IDEA Public Schools Electrical and Lighting Upgrades at RGV Campuses CSP#26-RGVLU-0424

## ADDENDUM NO. 2

**COVER**

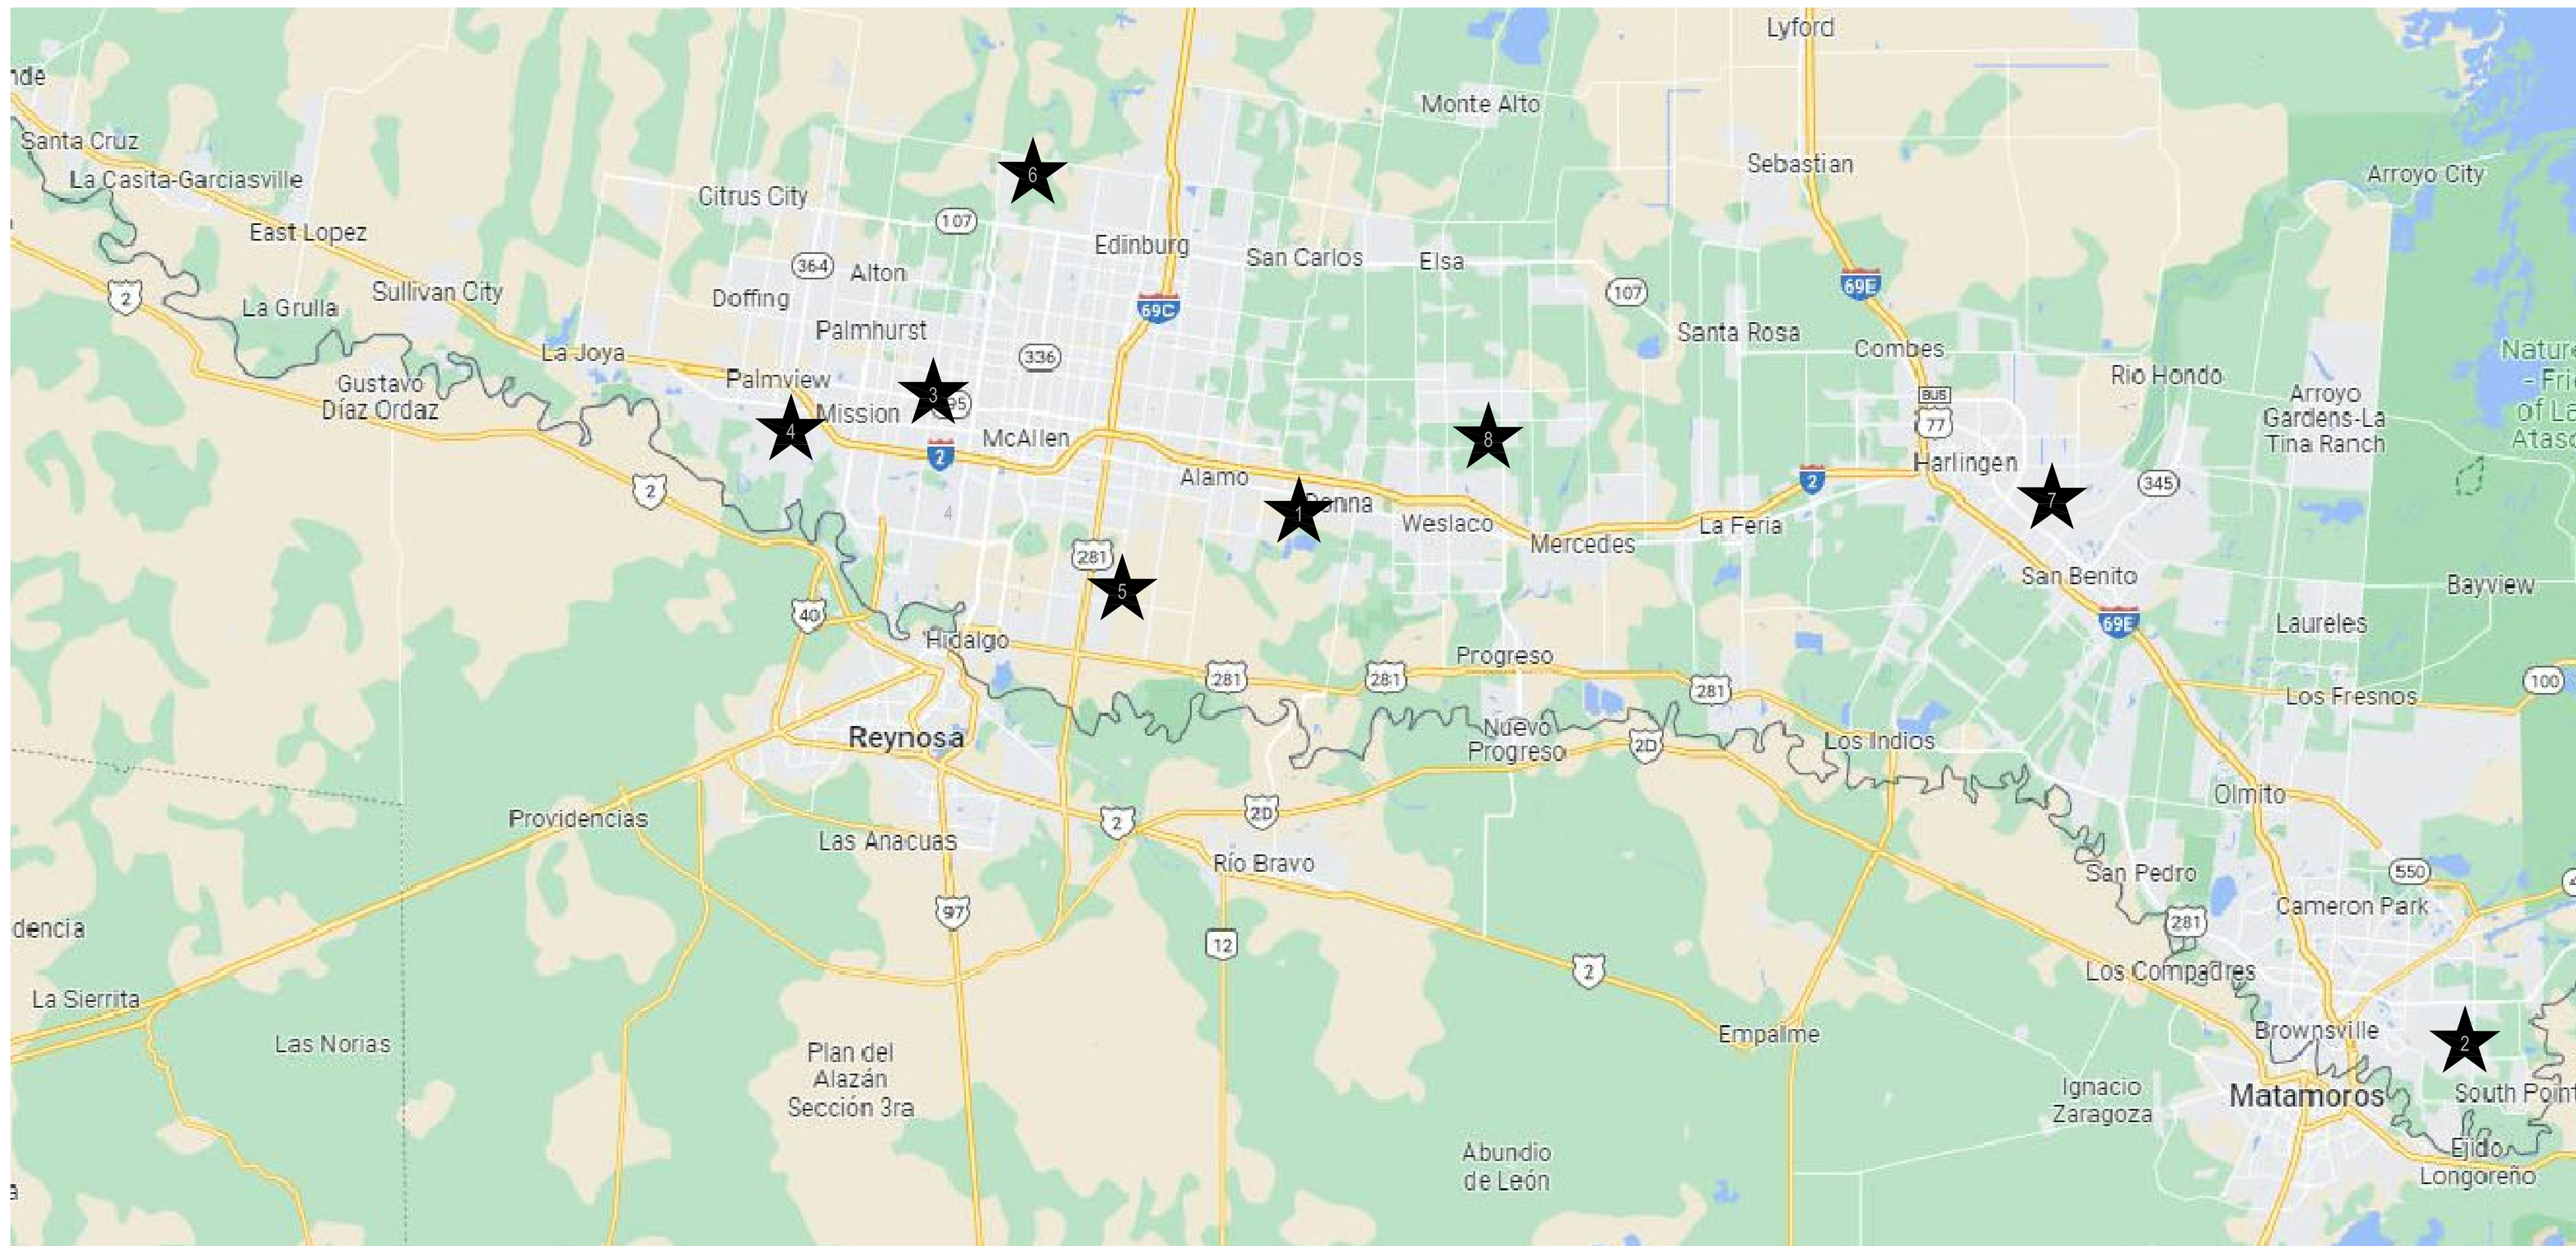
1. Cover:
  - a) Revised Executive Committee, Board of Directors, and Rio Grande Valley Regional Board. See attached sheet.
